工程指示 / 要求簡箋 (E.I.)

工程指示編號：EI / 5527 / 23 (原 EI 5272) 修改版次：L  
 工程編號：J - 858 工程名稱：將軍澳日出康城 LP 11  
 工程項目：幕牆 大貨單元件加工圖 **防火棉** 以此為準  
 收件人：生統 / 王良 / 水洪 發件人：Ant Yeung 日期：20/02/2023

**Proposed Residential Development at TKOTL 70RP, Phase 11, Lohas Park,  
Tseung Kwan O, N.T., Site C2**

Subject: **Site Observation for Matter on Fire Isolation Installation and Other Issues at 12/F BD of T1**

**Photo 1**

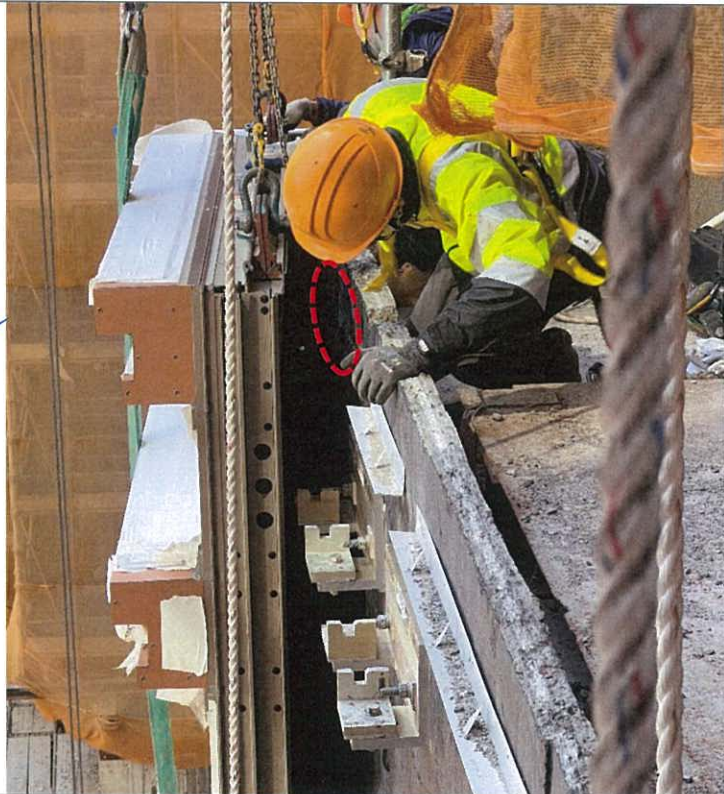
The retainer plate for fire insulation was observed to be damaged on the 12/F slab. It was removed after informed of MIDI.

**Photo 2**

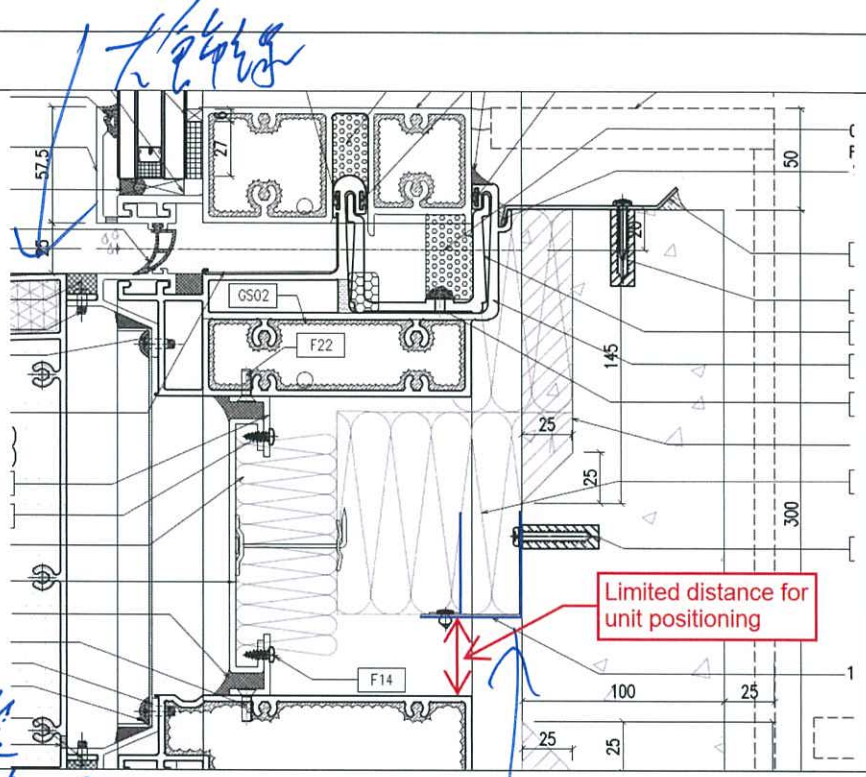
The retainer plate was observed to be removed due to the it will clash with unit during installation.

✓  
防跌梯托隨  
字樣  
↓  
✓

**Photo 5**

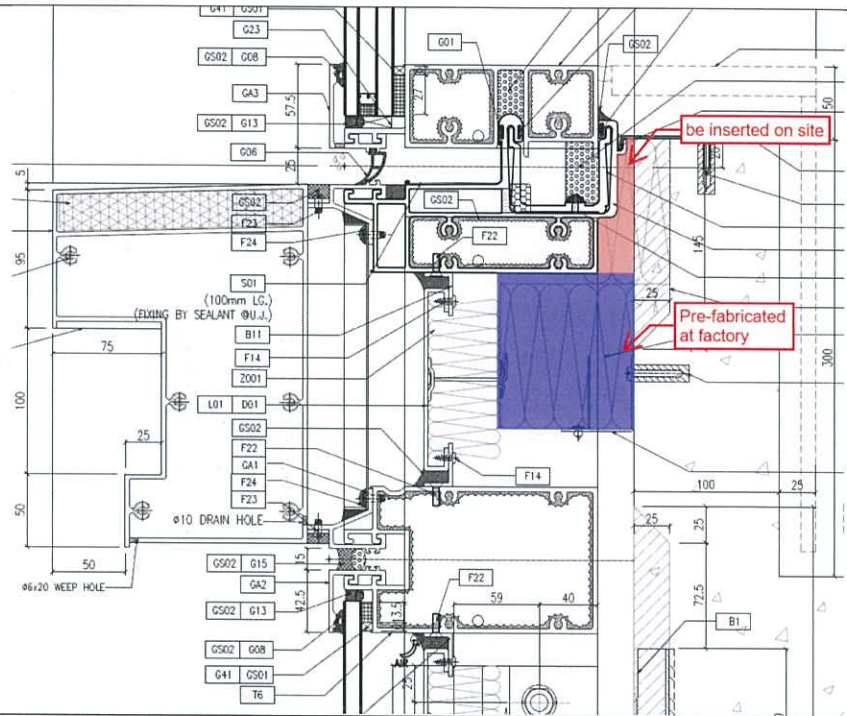
As per feedback from site, we recommend to pre-fabricate the fire insulation on to units at factory. And other parts of insulation can be inserted on site.

凡有能預製等元件  
在廠安裝更穩

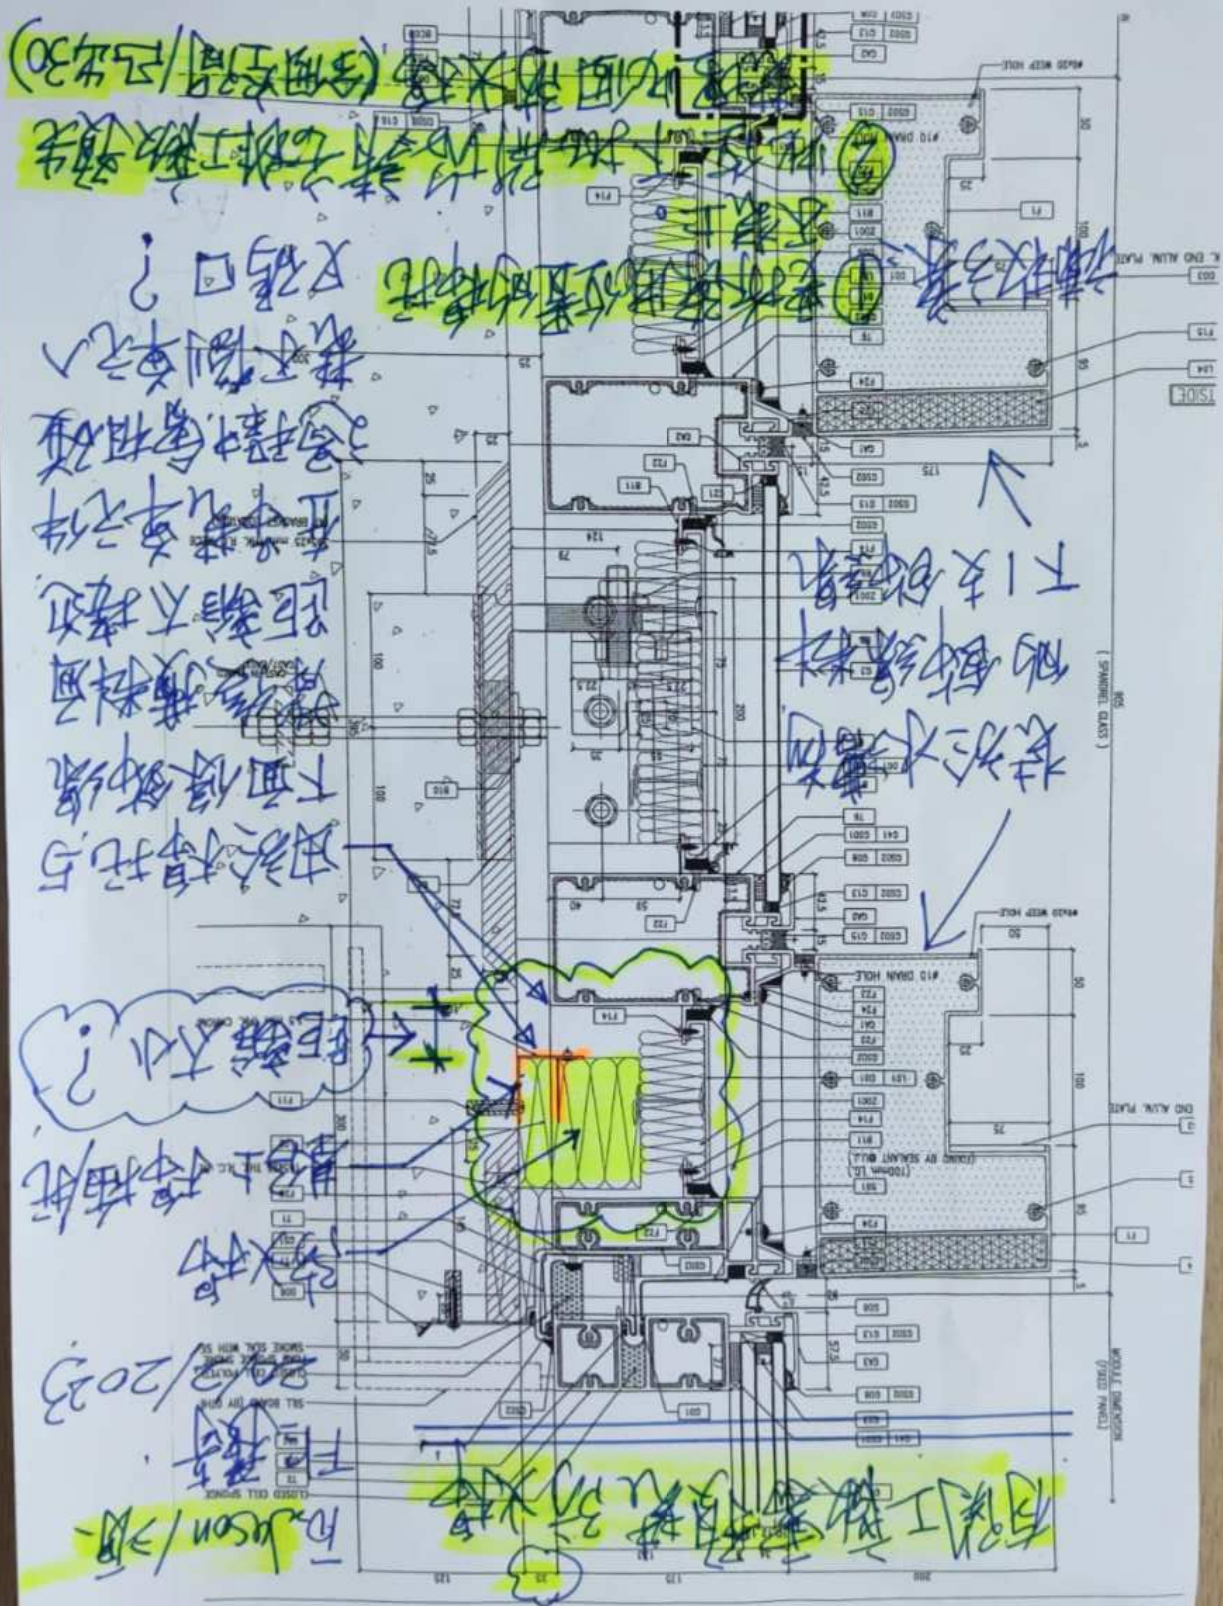
此零件請工程師先  
確認此圖的正確性 (參閱空間/23.4.30)

由於棉托與  
下面保飾線  
距離太接近  
導致橫料面  
距離不接近  
在裝車元件  
過程中會相碰  
甚至剝單元  
又碼頭?

是否有改進位置的棉托

裝於水櫃內  
的飾線材料  
下一支飾線

距離大小?
